# Service Bulletin

Bulletin No.: 18-NA-020

**Subject: Malfunction Indicator Lamp Illuminated with DTC P0300 and/or P0299/P2227 Set**

Brand:	Model:	Model Year:		VIN:		Engine:	Transmission:
		from	to	from	to		
Chevrolet	Equinox	2018	2021	-	-	Equipped with 2.0L or 1.5L Engine (RPOs LTG, LYX)	All
GMC	Terrain

5775941

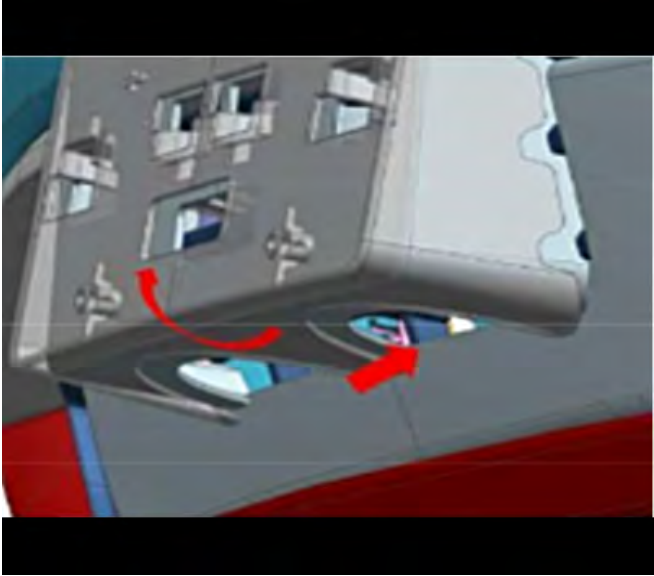
<p>*** For Terrains with front license plate bracket (VK3), install tape over the openings on bottom of the license plate bracket, to prevent airflow from bypassing the grill cover and flowing directly at the charge air cooler, as shown in the picture above.</p>

5736482

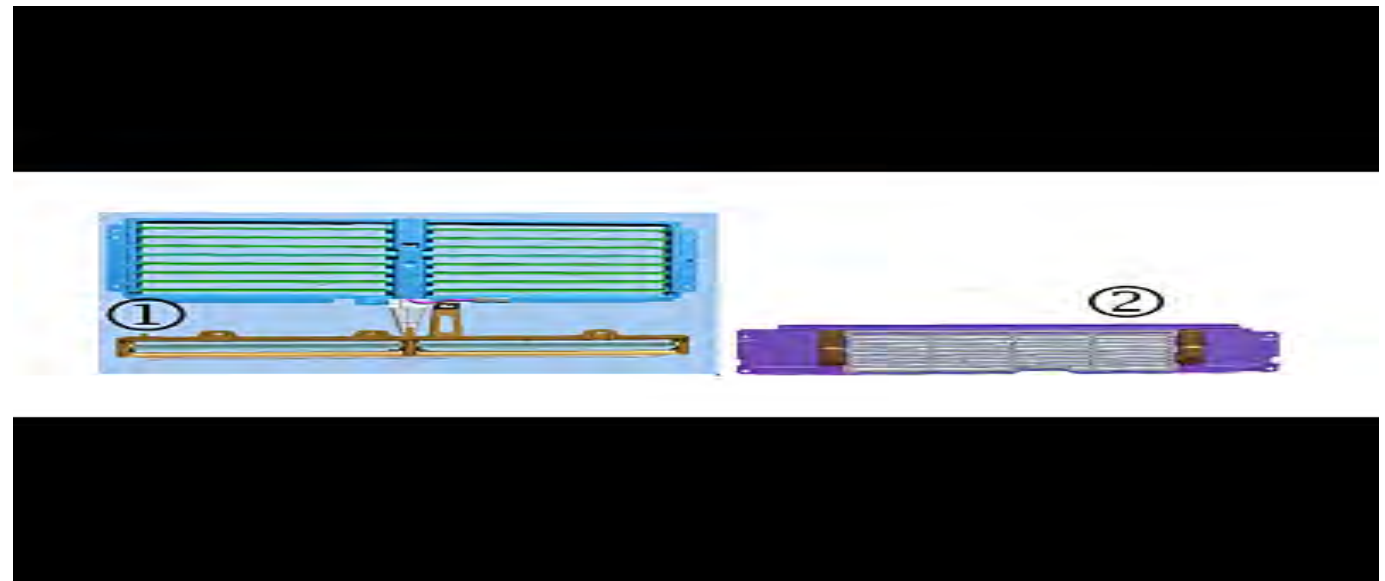
- Front Bumper Upper Shutter with the Front Bumper Secondary (lower) Shutter attached (1), as shown in the picture above.
- Front Bumper Lower Shutter that mounts in the front of Charge Air Cooler (2), as shown in the picture above.

5279924

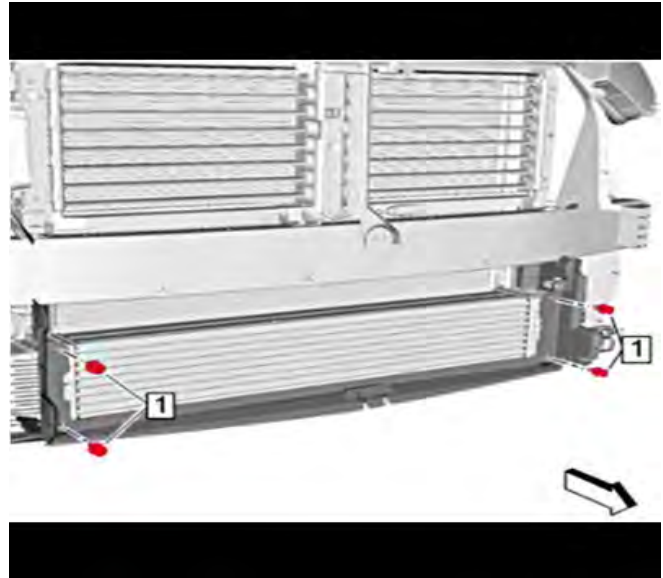
3. On the back of the now removed upper shutter, using a saw blade, cut the upper shutter to secondary (lower) shutter actuator at the pivot location, as shown in the picture above. Remove the linkage (1) and discard.
4. Reinstall the upper shutter.
